EVALUATION OF THE ERROR AND PROPOSED PATH FORWARD

SUMMARY OF CHANGES TO SAFETY ANALYSIS REPORT FOR PACKAGING: THE ORNL HFIR UNIRRADIATED FUEL ELEMENT SHIPPING CONTAINER

SAFETY ANALYSIS REPORT FOR PACKAGING THE ORNL HFIR UNIRRADIATED FUEL
ELEMENT SHIPPING CONTAINER

HFIR UNIRRADIATED FUEL SHIPPING CASK FIRE – CALCULATIONS OF WORST-CASE MELTING OF FUEL ELEMENTS

FIG. 2. SCHEMATIC OF OUTER PLATE

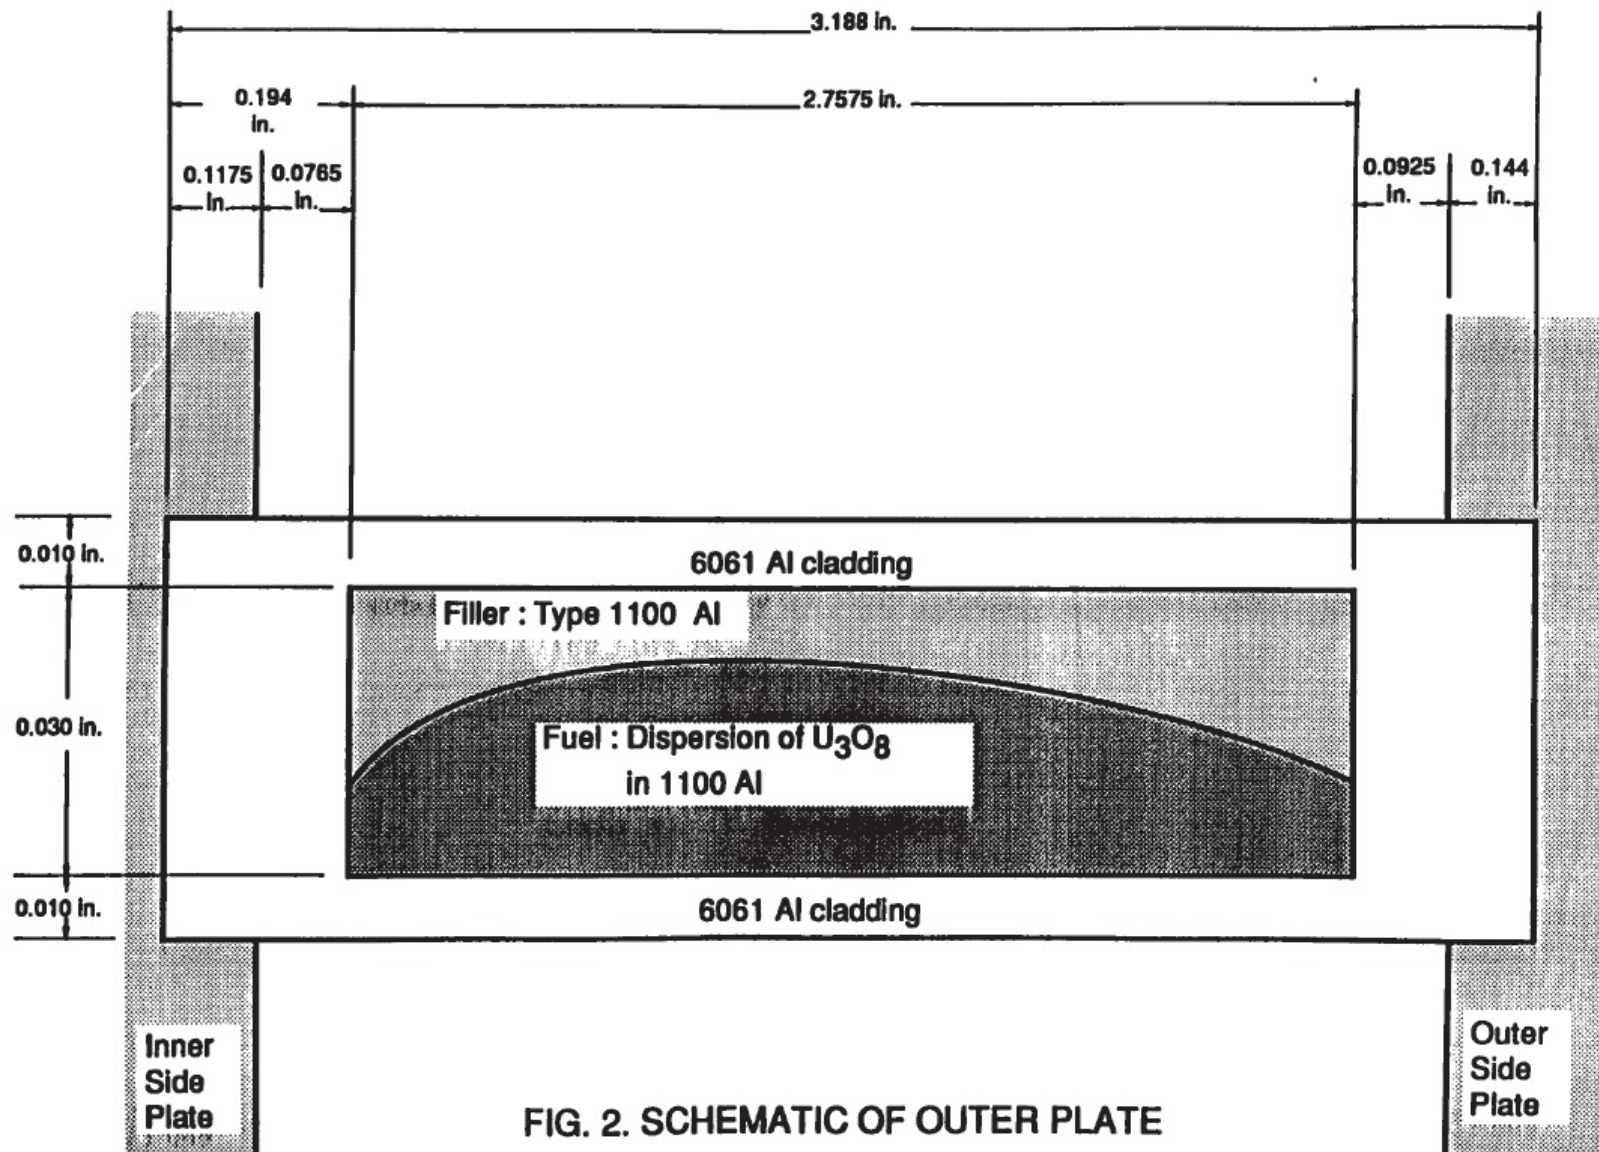
The analysis in Chapter 3, Appendix B, incorrectly assumed the pre-machined outer side plate thicknesses rather than the final thicknesses shown on the fuel element assembly drawings in Chapter 1 of the SARP (Drawings E-42118 and E-42126, included as Figures 1.7 and 1.8, respectively). The pre-machined outer side plate thickness of the outer fuel element is 0.408 in., whereas the final thickness is actually 0.128 in. (minimum). Similarly, the pre-machined outer side plate thickness of the inner fuel element was assumed to be 0.377 in. in the analysis, whereas the final thickness is 0.105 in. (minimum). Substituting the correct thicknesses in the existing analysis, and revising the initial starting temperature of the analysis to correspond to the maximum normal conditions of transport (NCT) package temperature (consistent with the requirements of 10 CFR 71), results in predicted melting of approximately 22% and 24% for the inner and outer elements, respectively.

Chapter 3, Appendix B, References, pg. B-9	References to the manufacturing side plate drawings were deleted. References for the side plate dimensions now call out the fuel drawings in Chapter 1.	The assembly drawings found in SARP Chapter 1 provide the correct final side plate dimensions.
Section 4.1, pg. 4-3 and (new) pg. 4-3a	Discussions of the A ₂ values associated with the fuel material for the inner and outer fuel elements were updated to reflect the current regulations.	There is no longer an A ₂ value for uranium enriched to > 20%. The appropriate A ₂ value was derived using the sum of fractions method for mixtures of normal form material, per 10 CFR 71, Appendix A.

A schematic of an outer fuel plate drawn as if it were flat is shown in Fig. 2. The dimensions of the plate are given in the fabrication drawing, ref. 4, and those of the side plates in the outer fuel element drawing (Chapter 1, Fig. 1.8). The dimensions shown in fig. 2 are the averages of the maximum and minimum values.

The side plate for the outer assembly is 0.128 in thick. The erosion of 0.128 in of aluminum side plate at 1.90 in/hr requires
